Service Bulletin

BKSB-1004
Issue Date 09-29-00

Issue: Possible EPH communication failure at high temperature (140 F+).

Affected Models: EPH FLEX-MODE models serial number 630000 to 032999.

Figure 2

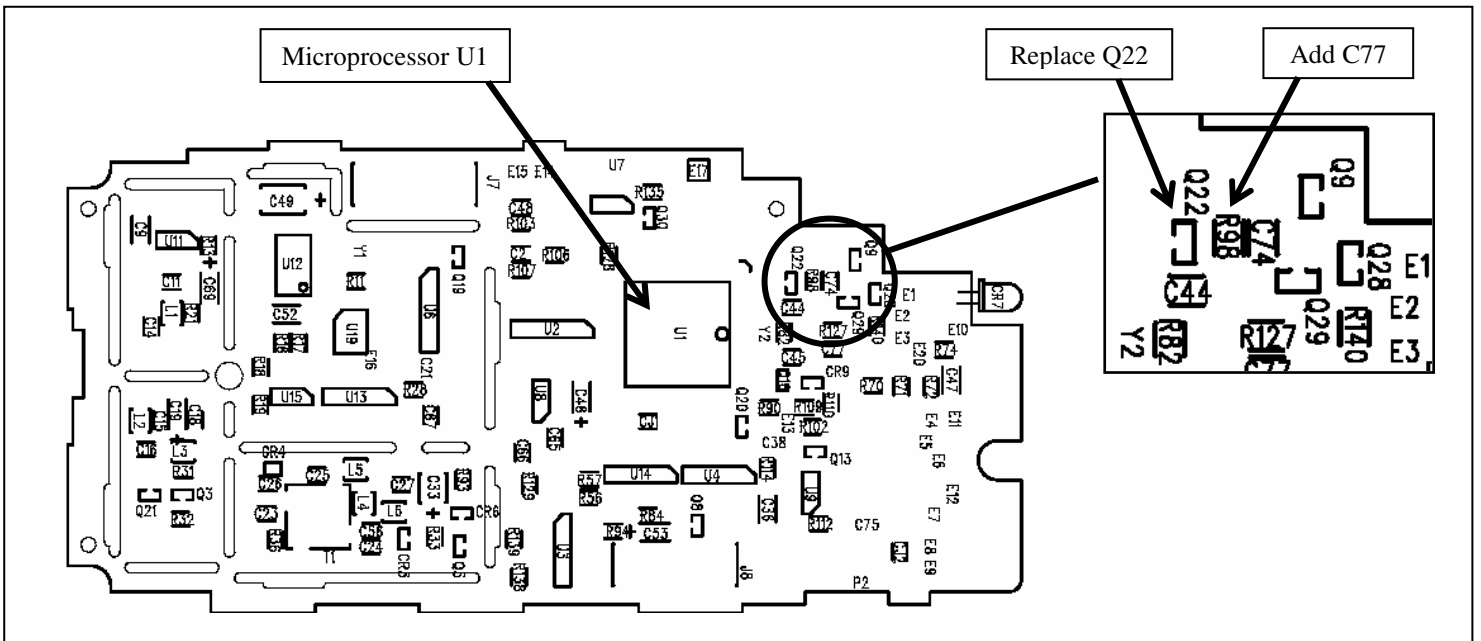
1. Turn off radio and remove battery.
2. Disassemble radio.
 - a) Remove 4 screws from rear cover of radio. (Fig. 1)
 - b) Pull front radio assembly straight out.
3. Check microprocessor (U1) for a white label marked 20061-803 or 7019-20061-803. If these markings are present this modification may be necessary. All other markings do not require modification.
4. On the System Board replace Q22 with new transistor, P/N 4823-20020-201. (Fig. 2)
5. On the System Board add capacitor C77, P/N 1553-50488-401, across resistor R98. (Fig.2)
6. Reassemble Radio.

- 1- 6.8pf surface mount capacitor; P/N 1553-50488-401.
- 1- MMBF4393 surface mount transistor; P/N 4823-20020-201.
- 1 - Low wattage soldering iron suitable for surface mount repair.
- 1 - Phillips head screwdriver; #0 tip.
